Access Compliance Report

Public Rights-of-Way

(Curb Ramps)

Intersection ID: 10161	Main Street: E_35TH_ST	Cross Street: YADKIN_AV	Location: W
ADA ID: 1417E6B17C15	Ramp Type: BlendTrans2	Initial Pass/Fail: Fail	Overall Compliance: No
Severity Score: 30			
Codes/Mitigation Info/Possible Solution		Field Measurements/Component Compliance

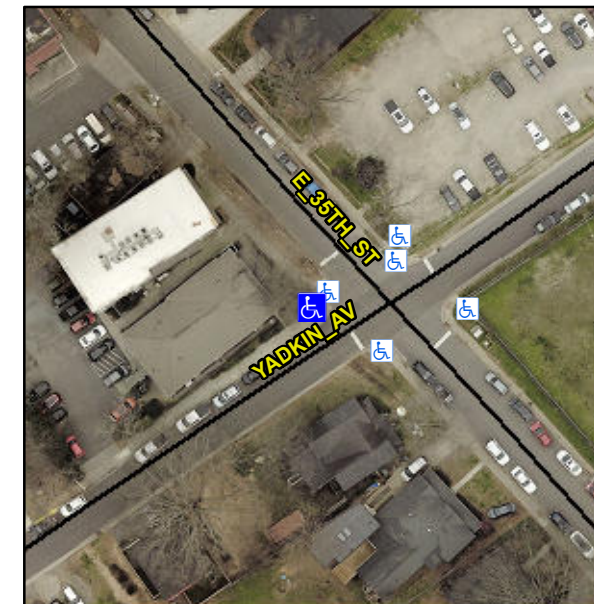
Not Found, R304.5.1, R304.5.3

Compliance	Description	Data	Compliance	Description	Data
N/A	Ramp Length (in)	83.5	Yes	BlendTrans Slope (%)	4.3
No	Ramp Width (in)	35.5	No	BlendTrans XSlope (%)	5.5
N/A	Flare Type LT	N/A	N/A	Flare Type RT	N/A
N/A	Flare Slope LT (%)	N/A	N/A	Flare Slope RT (%)	N/A
N/A	Flare Traversable LT?	N/A	N/A	Flare Traversable RT?	N/A
N/A	Landing Length (in)	N/A	N/A	DWS Provided?	N/A
N/A	Landing Width (in)	N/A	N/A	DWS Contrast?	N/A
N/A	Landing Slope (%)	N/A	N/A	DWS Length (in)	N/A
N/A	Landing X Slope (%)	N/A	N/A	DWS Full Width?	N/A
N/A	Landing Curb? (Y/N)	N/A	N/A	DWS Offset (in)	N/A
N/A	Shared Landing?	N/A			
N/A	Gutter Ponding?	N/A	N/A	Gutter Slope (%)	N/A
N/A	Gutter Lip Ht (in)	N/A	N/A	Gutter X Slope (%)	N/A
N/A	Painted X Walk1?	No	N/A	Painted X Walk2?	N/A
	X Walk 1 Direction	To SE		X Walk 2 Direction	N/A
	X Walk 1 Width (in)	N/A		X Walk 2 Width (in)	N/A
	X Walk 1 Slope (%)	3.1		X Walk 2 Slope (%)	N/A
	X Walk 1 X Slope (%)	2.7		X Walk 2 X Slope (%)	N/A

N/A	Ramp inside XWalk1?	N/A	N/A	Ramp inside XWalk2?	N/A
	Road Slope (%)	2.7		Clear Space?	N/A
	Road X Slope (%)	3.1	N/A	Clear Space to XWalk (in)	N/A
N/A	Any Obstructions?	N/A	N/A	Storm Grate/Utility Hazard?	N/A
	Obstruction Type			Storm Grate/Utility Type	
		N/A			N/A
			Yes	Surface Condition? (G/P)	Good
			No	Curb Slope (%)	11.1

Remove & Replace Curb Ramp With Two New Directional Ramps or Equivalent.
